Track Expert Review of

LA Metro

Exposition Line Two Track At-Grade Junction

Final Report

Figure 3. Comparison of L/V Ratio on the Lead Right Wheel through a Standard Frog (Green) and Expo Frog (Red)

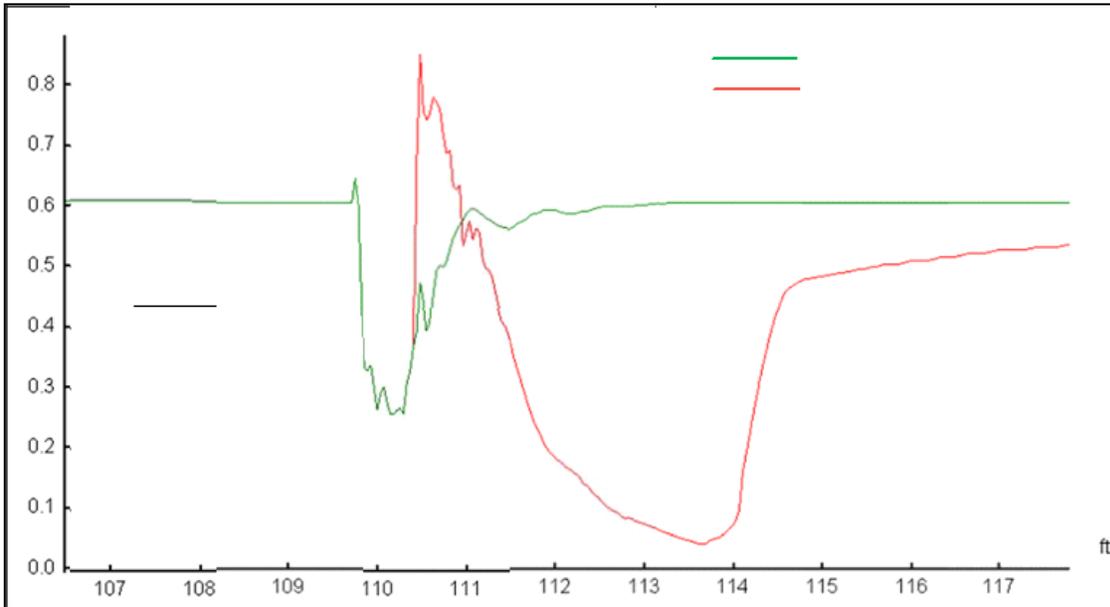
As can be seen from this Figure 3, the Expo frog movement showed an L/V ratio of 0.8, as opposed to the standard movement of 0.6. While 0.8 is sometimes regarded as the “minimum” L/V threshold, ZETA-TECH performed a more detailed analysis of the L/V ratio threshold as a function of the actual wheel flange angle and coefficients of friction using the Nadal wheel climb analysis methodology. The results of the analysis showed that for the new wheel flange angle of 75 degrees (the same as was used by ENSCO in the modeling run) and for a range of coefficient of friction of 0.3 to 0.5, the actual L/V derailment threshold is 1.13, well above the model calculated L/V ratio through the Expo frog (of 0.8). This indicates that there is no risk of wheel climb, since the L/V ratio was less than the Nadal calculated derailment threshold.

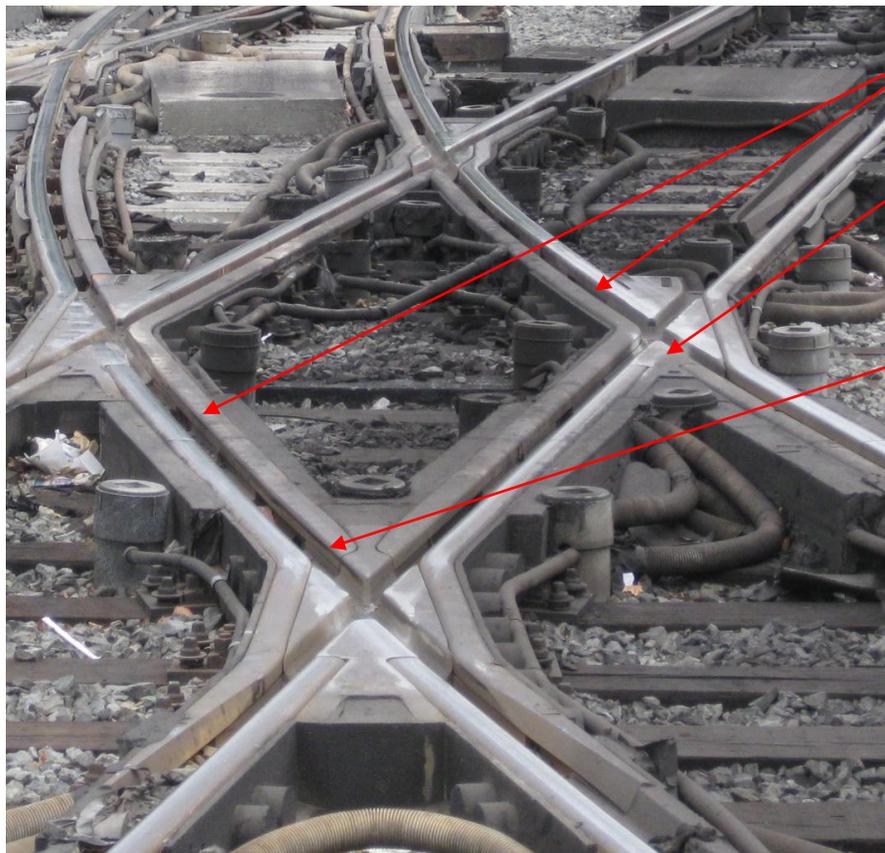
- c) There has been a concern expressed about the ability to transition from the R190 frog at 57 inch gauge¹ to the newly gauged diamond at 56 ½ inch. Should the frog be regauged as well to 56 ½ inches and if not, is there a problem having this transition over such a short distance?

It would be better if the frog diverging route was reset to standard gauge so that there would be no transition and the frog wing rail would not be subjected to the observed high wear (as noted in Figure 7). However, if, due to time and cost restraints, this procedure is not a realistic option, this lack of transition does not represent a serious problem so long as the "line" rail remains uniform throughout this transition zone. The change in gauge must be facilitated by moving the "grade" rail (inside rail) closer to the line rail by ½ inch and NOT moving the "line" rail from its current position. This transition should take place over a distance not less than the longest axle to axle spacing of any vehicle using this route. In this case, 82.7 inches.

Figure 12A: Replacement Junction Configuration

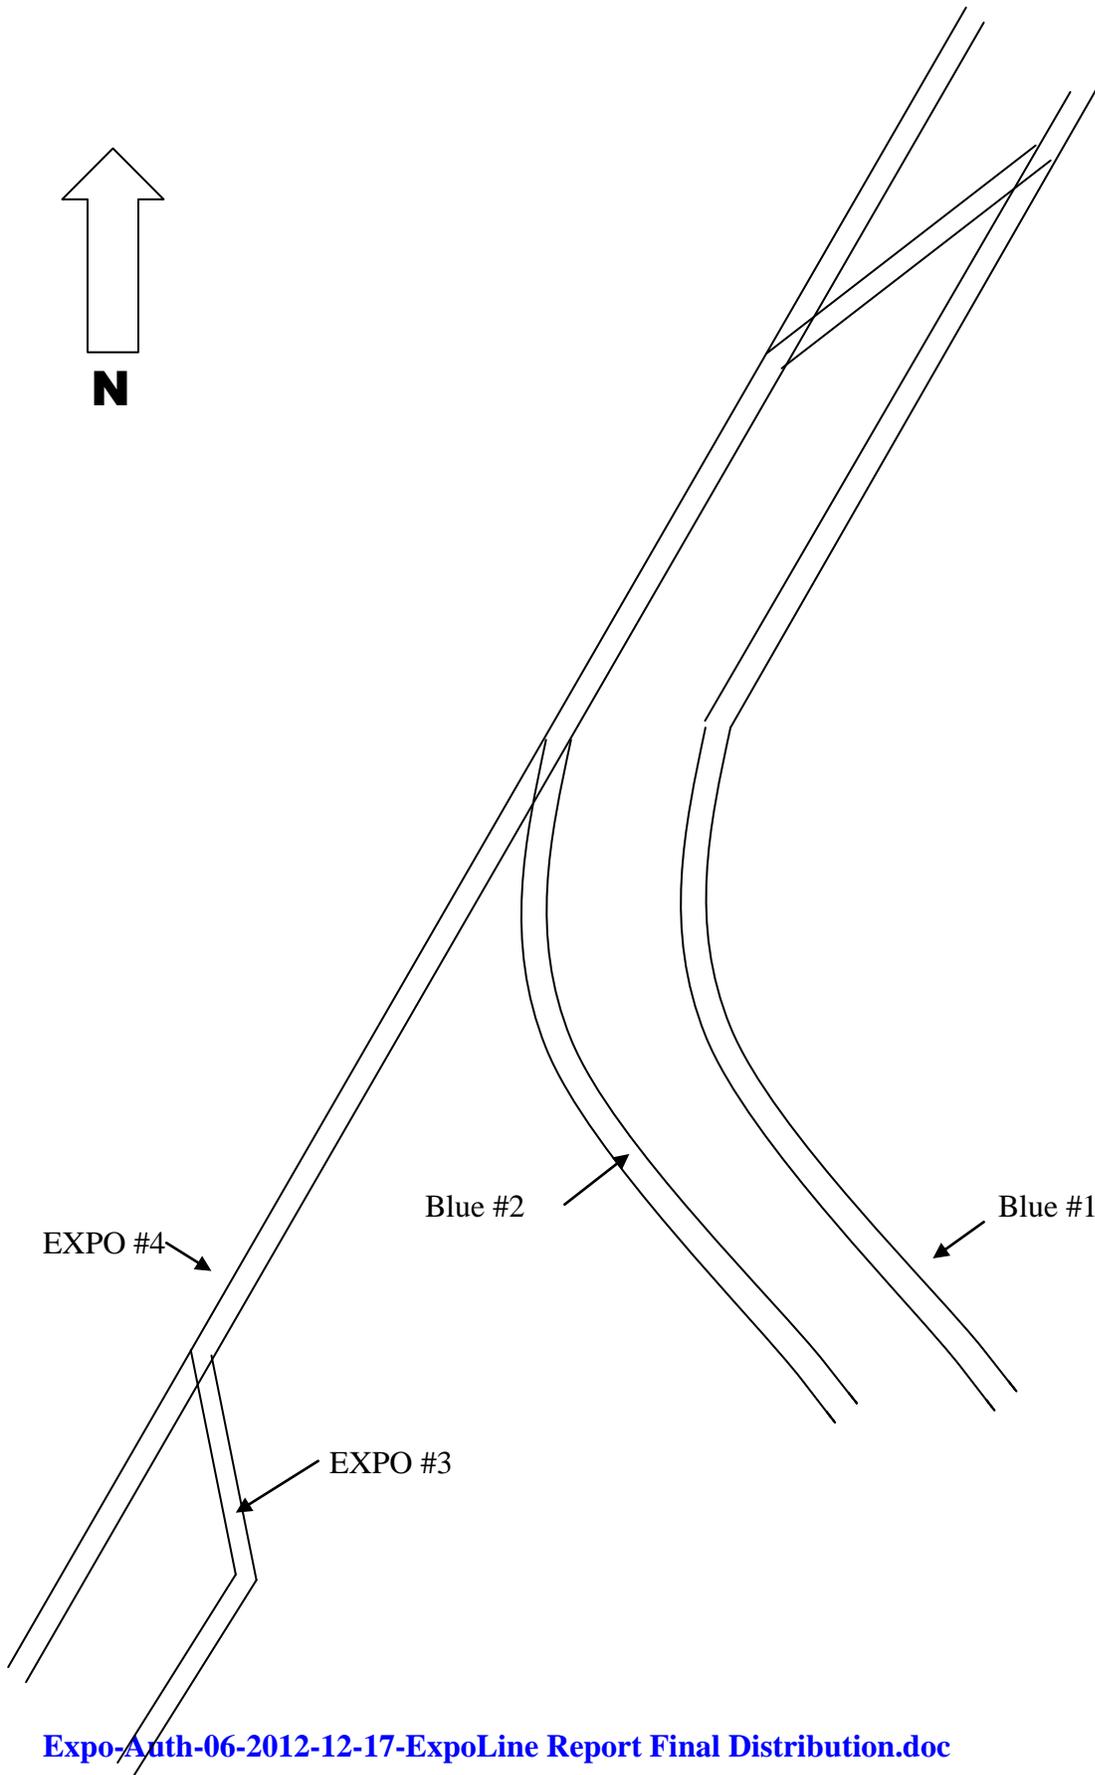
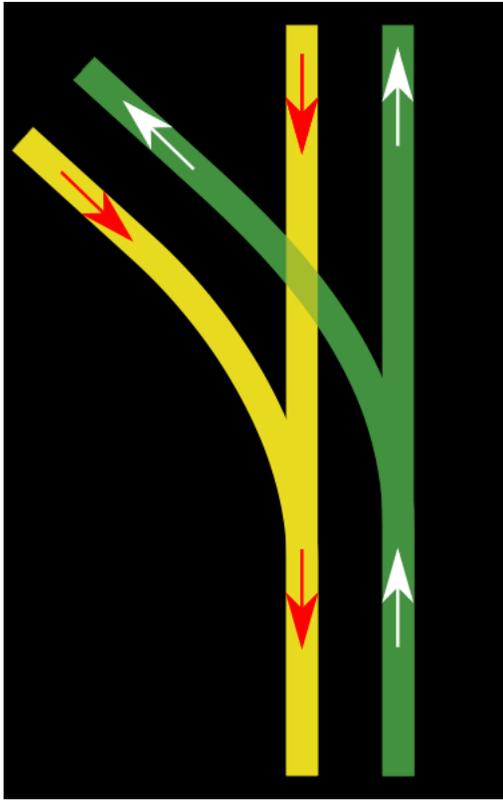
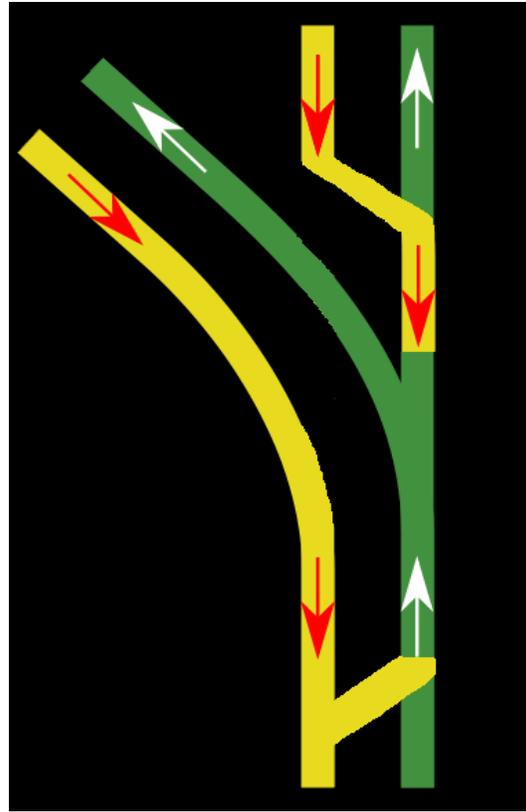
The diamond junction was originally installed to provide the greatest level of operating flexibility. However, due to space limitations, the diamond had to be designed with a 150 foot radius curve which limits train speed and may present maintenance issues. The full diamond junction can be replaced with a crossover. This would remove the existing diamond configuration and its associated maintenance problems, and increase speed of operation through this junction area.

This is accomplished through the new –proposed- junction configuration shown in Figure 12A. In this configuration, EXPO#3 is joined to EXPO#4 south of Flower Street, then single tracked across the roadway and through the 4.5 turnout, with a cross-over installed to bring EXPO#3 back over to Blue#1. The diamond could then be removed and Blue#2 would be connected directly to the number 4.5 turnout (see Figure 12A.).

If this level of operation is acceptable, then it is strongly recommended that the diamond be eliminated and replaced with this new, higher speed, operating configuration. In addition to the higher operating speeds, this configuration would greatly reduce the level of maintenance at this junction. However; it is possible that this layout may impact and limit future operating flexibility and headways and therefore must be reviewed and approved by Operations prior to any modifications being made.

Figure 13: Correction of Gauge

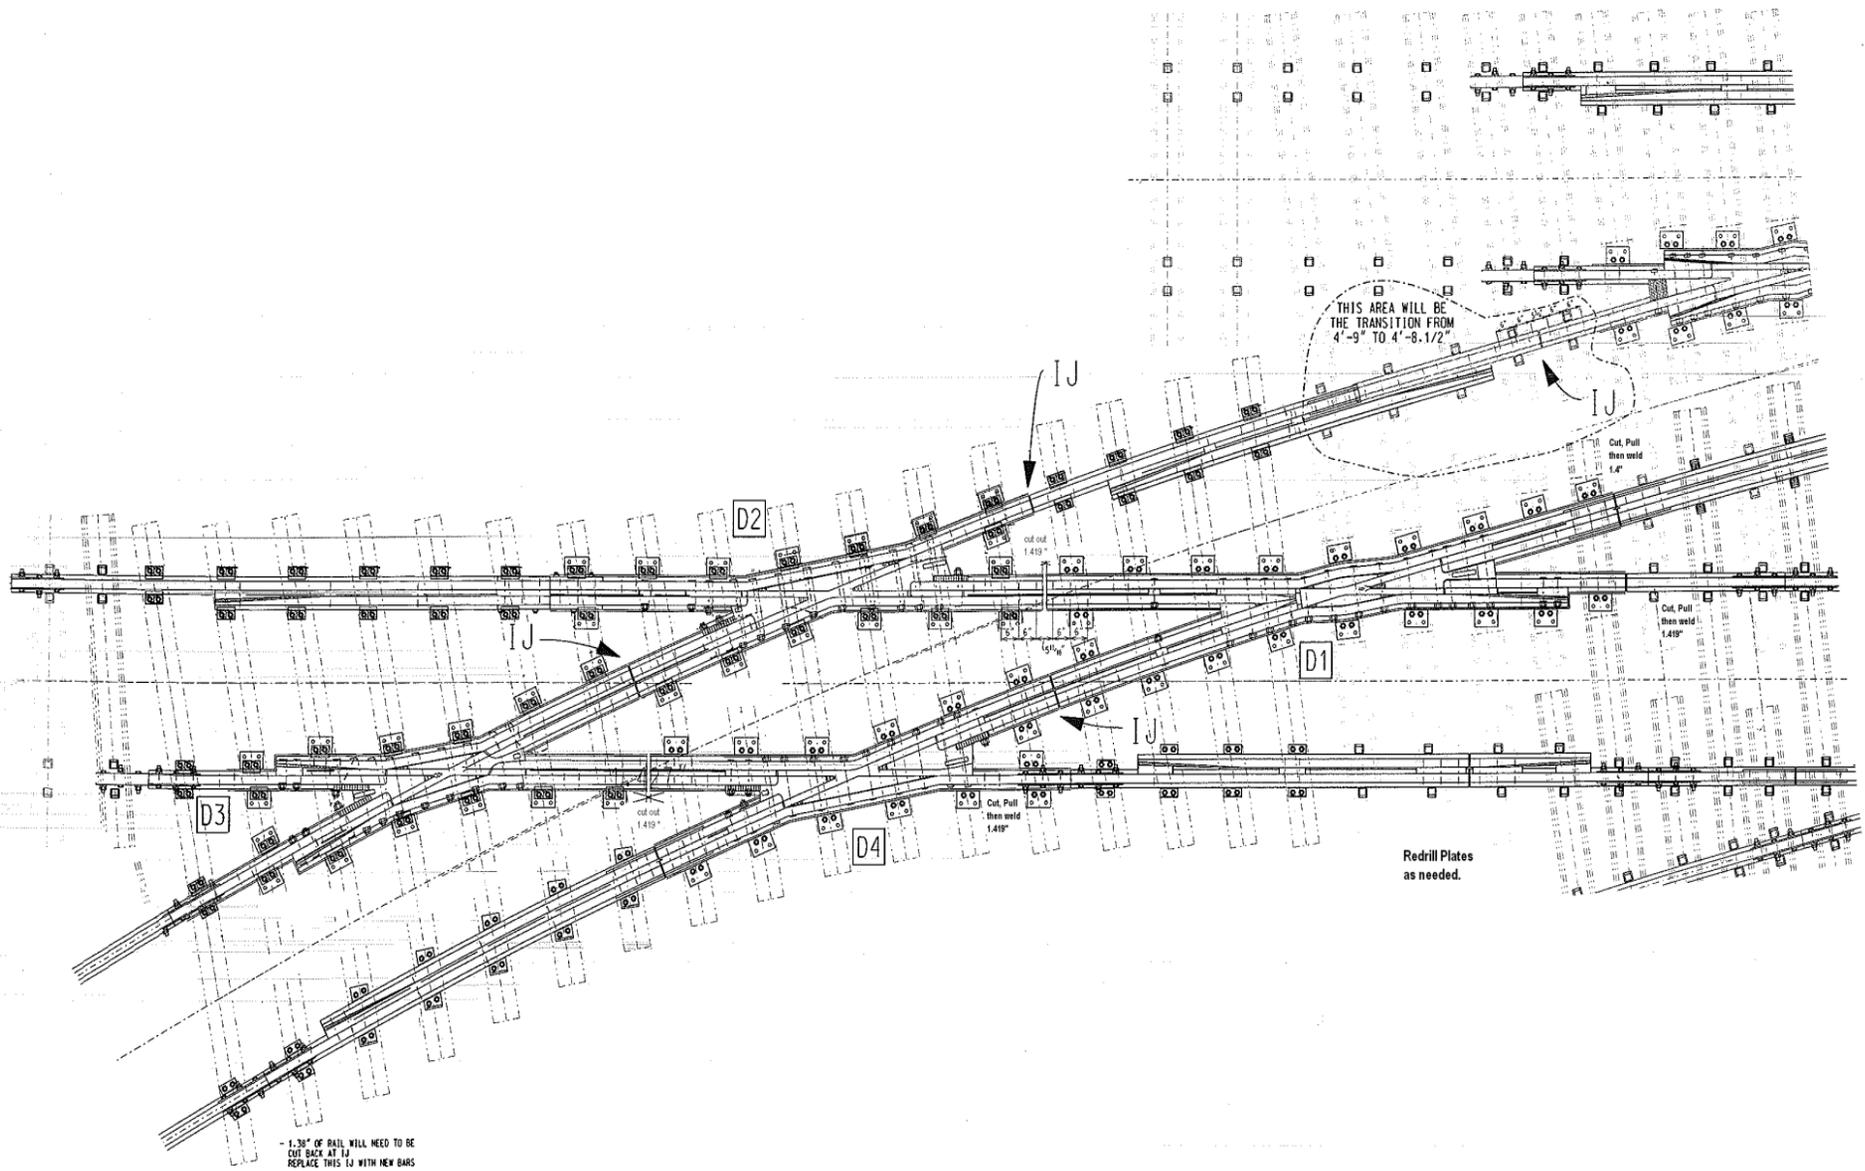
As noted previously, the problem with the existing diamond is the fact that the gauge through the diamond on track Blu#2 has been widened to 57” resulting in the back of flanges of passing wheel sets being pinched between the flangeway guardrails. To mitigate this problem, the gauge must be returned to 56 ½ inches. This can be done by either:

Of these two gauge restoration options, B3b is recommended.

1. Cut the running rail and guard rail in the center of the diamond between frogs D1 and D2, removing a section of rail equal to 1.419 inches.
2. Perform the same rail removal between frogs D4 and D3.
3. North of the diamond, cut both running rails on track EXPO#3.
4. North of the diamond cut the north rail of Blue#2.
5. Also, south of the diamond, cut the north rail of Blue#2 and remove 1.38 inches of rail.
6. Loosen all fasteners between all rail cuts and pull the north rail of track Blue#2 together at the cuts noted in steps 1 and 2.
7. Weld or bolt up all remaining rail cuts and reset all plates and fasteners as needed.
8. Replace insert at D2, removing both ramp and “blip”.
